PRODUCT/PROCESS CHANGE NOTICE (PCN)

PCN #: **TB1503-01 (R1)** DATE: **October 23, 2015**

Product Affected: **TSSOP-20, TSSOP-24, TSSOP-28,
TSSOP-48, TSSOP-56, TVSOP-48
SOIC-28, SSOP-20, SSOP-28,**

Figure 1: Additional Label pasted on ESD/Moisture barrier bag and Pizza box

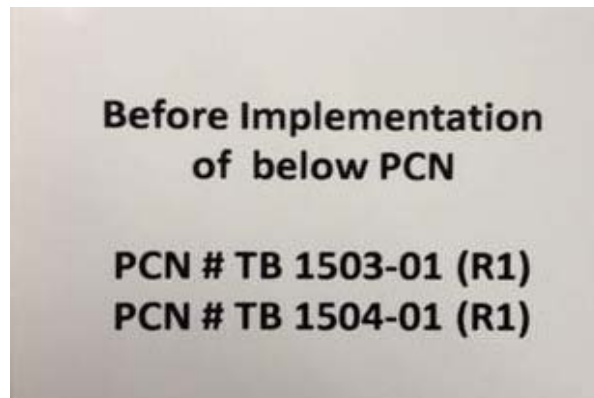
Customers may expect to receive shipments of products in new packing no sooner than 90 days from the date of this PCN notification. Shipments to customers may contain products shipped with either the existing packing or new packing during the transition period. Shipments made in the existing packing after the PCN becomes effective will have an additional label pasted on the ESD/moisture barrier bag and pizza box.

Illustration of Carrier Tape Pocket Design Change

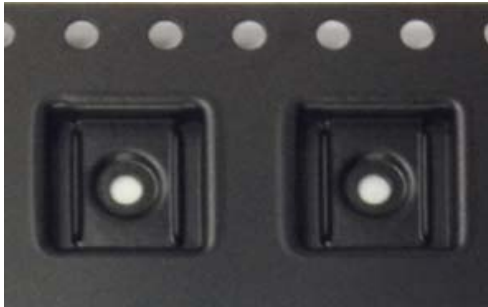
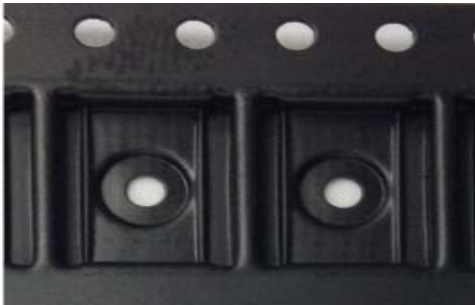
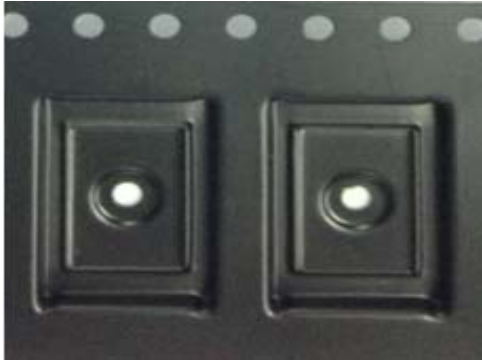
Package	From	To
TSSOP-20	Carrier Tape Part# P8-464-000 	Carrier Tape Part# P8-291-P20 
TSSOP-24	Carrier Tape Part# P8-329-P24 	Carrier Tape Part# P8-169-P24 
TSSOP-48	Carrier Tape Part# P8-260-P48 	Carrier Tape Part# P8-324-P48

Illustration of Carrier Tape Pocket Design Change

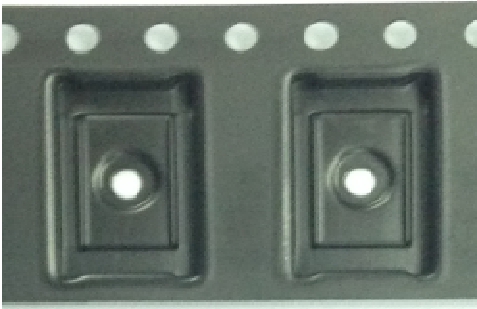
Package	From	To
SOIC-28	Carrier Tape Part# P8-187-S28 	Carrier Tape Part# P8-370-P28 
TSSOP-28 and TVSOP-48	Carrier Tape Part# P8-145-PF8 	Carrier Tape Part# P8-330-P48 
TSSOP-56	Carrier Tape Part# P8-261-P56 	Carrier Tape Part# P8-314-P56

Illustration of Carrier Tape Pocket Design Change

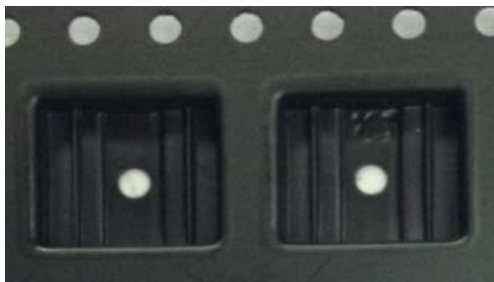
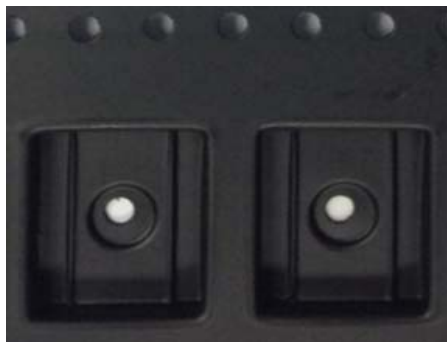
Package	From	To
SSOP-20	Carrier Tape Part# P8-259-P20 	Carrier Tape Part# P8-320-P20 
SSOP-28	Carrier Tape Part# P8-384-P28 	Carrier Tape Part# P8-321-P28
